AMENDMENTS TO THE DRAWINGS

REMARKS

Figure 1

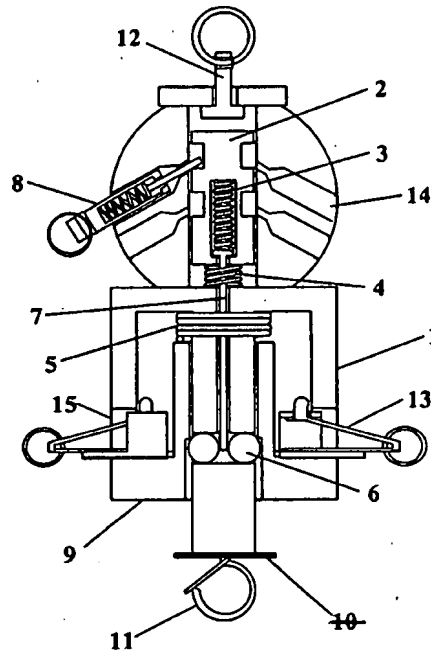
The Examiner objects to the drawings as failing to comply with 37 CFR 1.84(p)(5) because they include reference characters not mentioned in the description, namely "10" and "11" shown in Figure 1. Applicant has amended the description to indicate what corresponds to reference character "11". Applicant notes that this reference character was inadvertently omitted from the description but the specific item to which it refers was nonetheless clearly described in the text. Applicant has amended Figure 1 to no longer depict reference character "10".

The Examiner objects to the drawings as failing to comply with 37 CFR 1.84(h)(4) because Figure 1 has two views. Applicant has amended Figure 1 to recite each view as "A" and "B".

In Figure 1, the upper view has been labeled "A" and the lower view has been labeled "B". Additionally, the reference character "10" has been deleted from the figure.

Figure 5

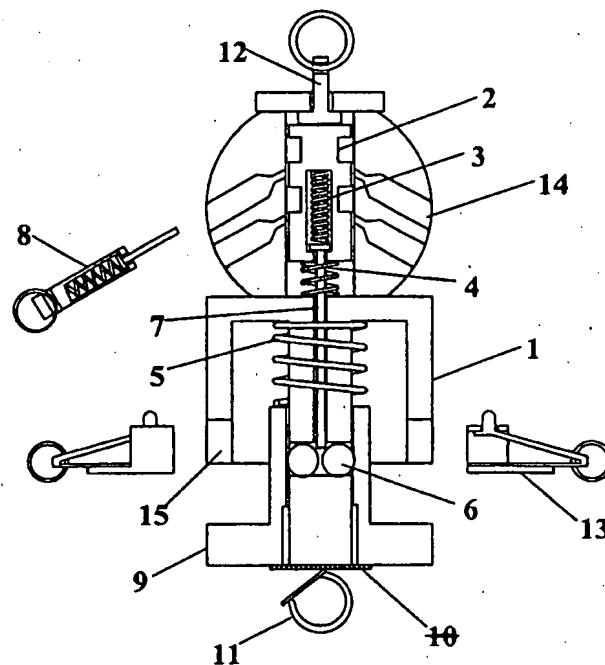
The Examiner objects to the drawings as failing to comply with 37 CFR 1.84(p)(4) because reference character "2" has been used to designate both a spring pin without an extension (Figures 1, 3, and 4) and a spring pin with an extension (Figure 5). Applicant has amended Figure 5 and labeled the spring with an extension with the reference character "2'" as suggested by the Examiner.

The Examiner objects to the drawings as failing to comply with 37 CFR 1.84(p)(4) because the reference character "8" has been used to designate both spring trigger with an internal spring (Figure 1) and spring trigger without an internal spring (Figure 5). Applicant has amended Figure 5 and labeled the spring trigger without an internal spring with the reference character "8".

In Figure 5, the spring with an extension has been labeled with the reference character "2'", and the spring trigger without an internal spring has been labeled with the reference character "8'".
